Interactive comment on “Assimilation of space-based passive microwave soil moisture retrievals and the correction for a dynamic open water fraction” by B. T. Gouweleeuw et al.

Anonymous Referee #1

Fig. 1.

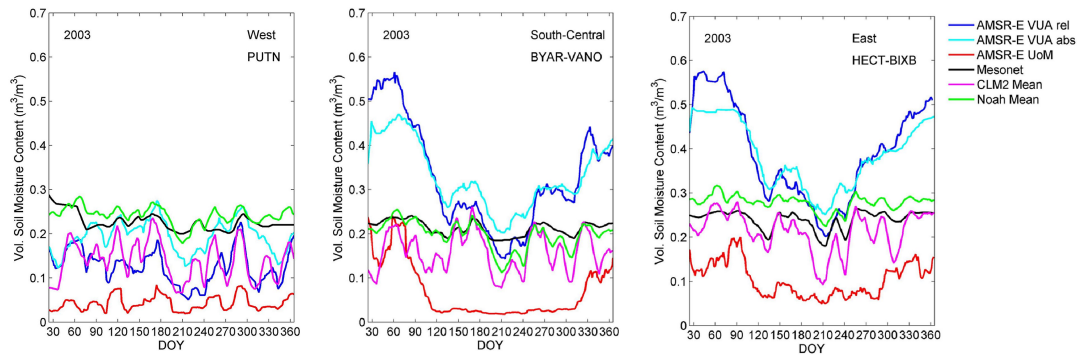
Figures 1-2: This 2 figures can be easily merged.

Figures 2: Please specify in the caption the meaning of the grids and the dots.

Reply: The two figures have been merged, as suggested.

Reply: The meaning of the dots have been specified in the Figure 2 (now Figure 1) caption:
